## AMENDMENTS TO THE DRAWING FIGURES

## REMARKS

Figure 2

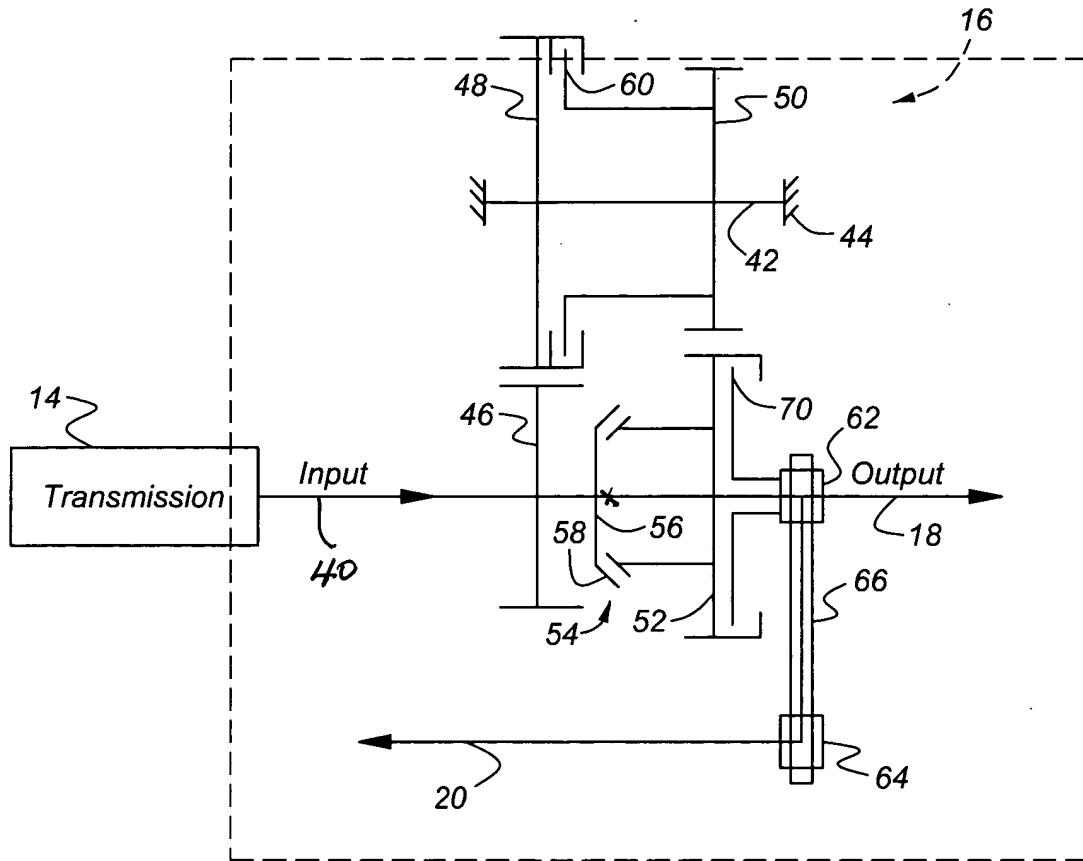
In Figure 2, coupler 54 connects and disconnects input 40 and output 18 as described in the specification; therefore the input 40 and output 18 are now shown disconnected at the location of coupler 54.

Figure 4

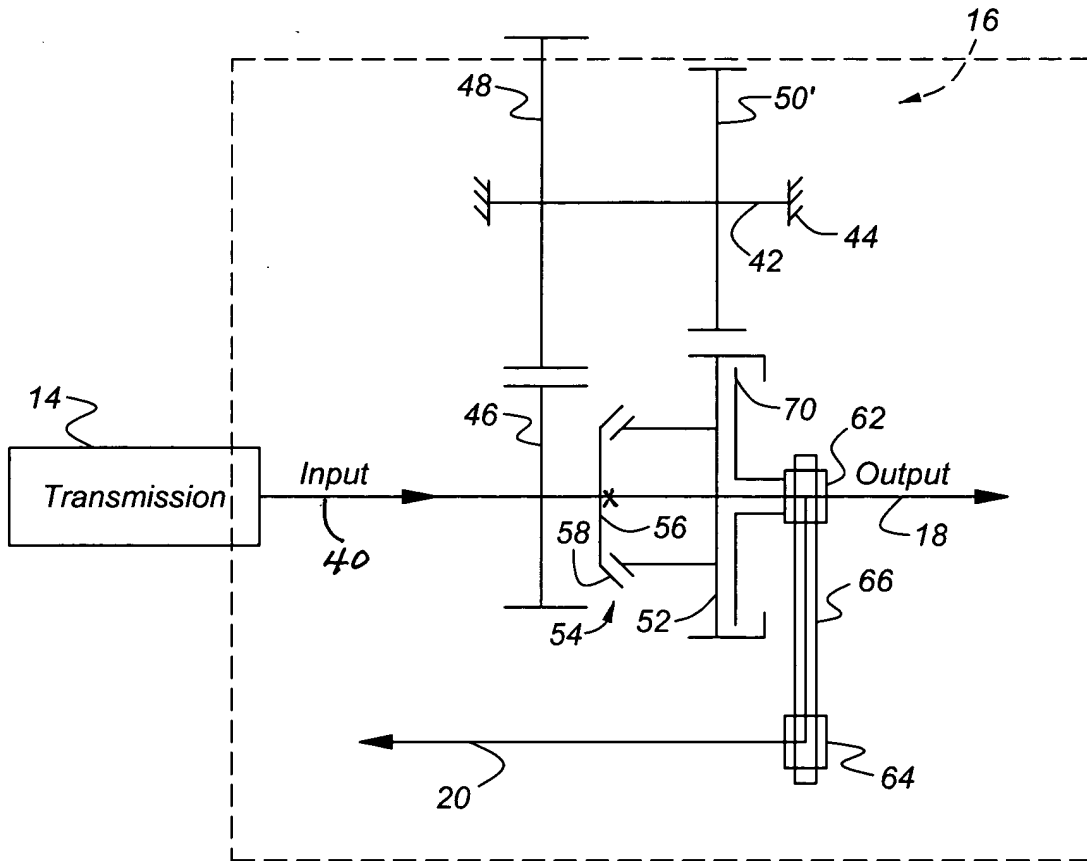
In Figure 4, coupler 54 alternately connects and disconnects input 40 and output 18, as described in the specification; therefore the input 40 and output 18 are now shown disconnected at the location of coupler 54.

The drawings stand objected to due to an informality present in Figure 4. Applicant has proposed to correct this informality to make other changes to the figures as discussed herein.
